SERVICE LETTER #46

SUBJECT: New Flap Ratchet.

AIRCRAFT AFFECTED: MAULE Model M-5-210C, Ser. No. 6001C thru 6206C.

### INSTALLATION INSTRUCTIONS

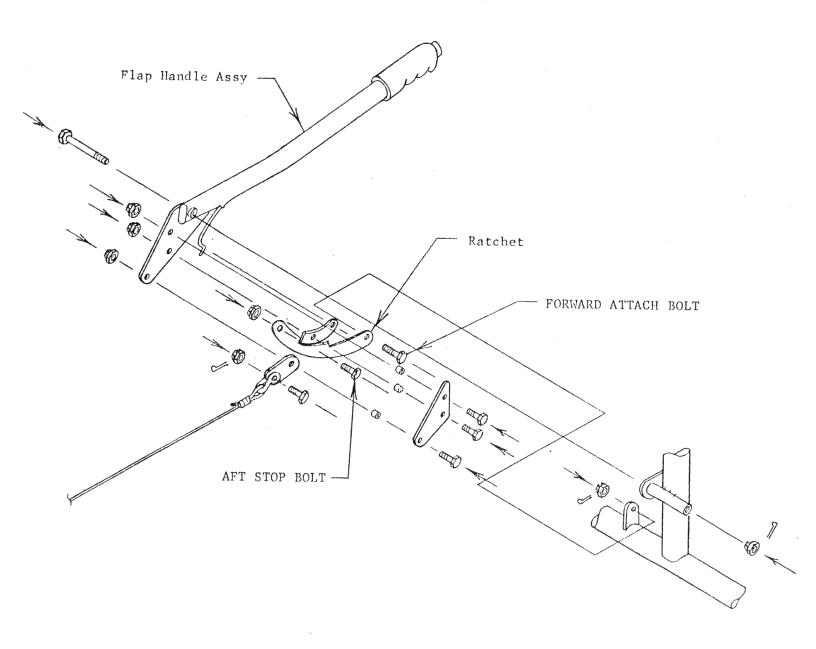
BACKGROUND: Many MAULE owners have requested increased flap travel for their airplanes. The new flap ratchet allows 5° - 8° more travel at each setting. There is also available an alternate lever which is bent upward. This allows more clearance under the lever for easier grasping. Either unit can be used separately.

- 1. Remove left front seat.
- 2. Remove control cover (ref. Item 6, Group C-4 of Parts Catalog)
- 3. Remove old ratchet:
  - (a) Remove forward ratchet attach bolt and nut.
  - (b) Remove aft stop bolt and nut.
  - (c) Slide ratchet forward thru plates of flap handle assembly.
- 4. Install new ratchet:
  - (a) Slide ratchet aft thru plates of flap handle assembly.
  - (b) Install forward attach bolt and nut and secure with cotter pin.
  - (c) Install aft stop bolt and nut removed from old ratchet.

NOTE: 20°-40° ratchet has forward stop bolt and nut deleted.
  - (d) Operational check flap system.
- 5. Reinstall control cover.
  - 6. Reinstall left front seat.
  - 7. Remove 15°-35° placard from flap handle and apply new placard.
  - 8. Remark Airspeed Indicator: Extend white arc from 56 to 48 mph by applying white tape over instrument glass. Add slippage mark by painting a thin white line over glass and bezel.
  - 9. COMPLY WITH MAULE SERVICE BULLETIN #7. (AD#86-17-11).
- 10. Attach AFM Supplement No. 5 to FAA Approved M-5-210C Airplane Flight Manual dated 28 December, 1973.
